TRANSMITTAL OF MEETING HANDOUT MATERIALS FOR IMMEDIATE PLACEMENT IN THE PUBLIC DOMAIN

TO DISCUSS THE LICENSEE'S MAY 1, 2001,
REQUEST FOR EXEMPTION FROM THE
DEFINITION OF DEEP-DOSE EQUIVALENT

**Request for Exemption from 10CFR 20.1003
Definition of “Deep-Dose Equivalent” and Permission
to Use External Whole Body “Weighting Factors”
Other than 1.0**

**Entergy's Response to NRC
Completeness and Acceptance Review of
Entergy's Request for Exemption from the
10CFR 20.1003 Definition of Deep-Dose
Equivalent (DDE) Dated 5/29/01**

Graph plotted using data in Table 3 of ANSI N13.11-1993 "Personnel Dosimetry Performance – Criteria for Testing" and data in Reference 5.7 of the exemption request. For Cs-137 source E=662 keV.

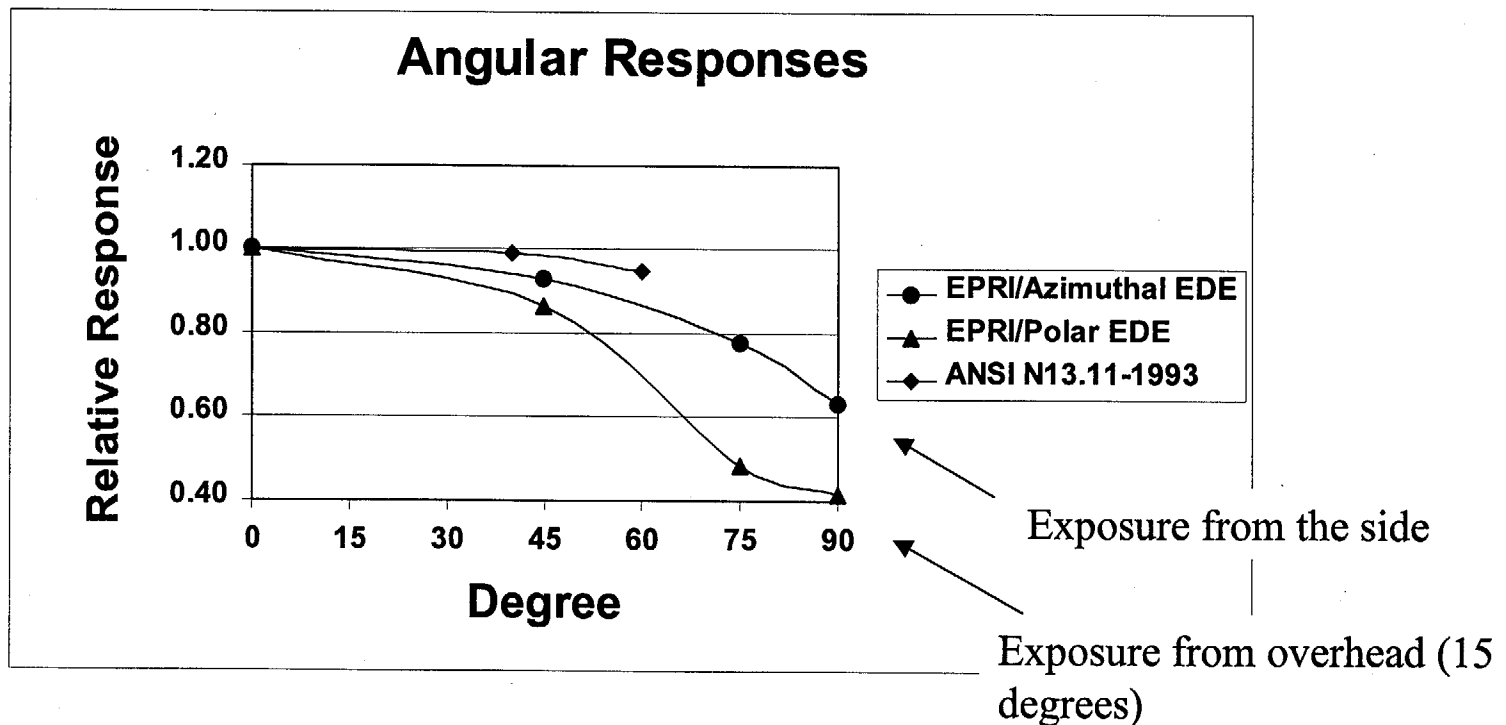
Provide the directional response summary of the dosimeters planned for use and how directional sensitivity will be accounted for.

The dosimeters to be used in the EPRI EDE methodology are the same dosimeters used for compliance with the NRC approved methodology and have the same directional response. A February 1995 article in "Health Physics," (Reference 5.7 of the exemption request) describes the effect of directional response on the EPRI EDE methodology and on the NRC approved methodology. [See attached graph comparing ANSI standard and EPRI EDE results.]

The comparison shows that all dosimeters are required to have a conservative angular response curve compared to EDE for up to 60 degrees.
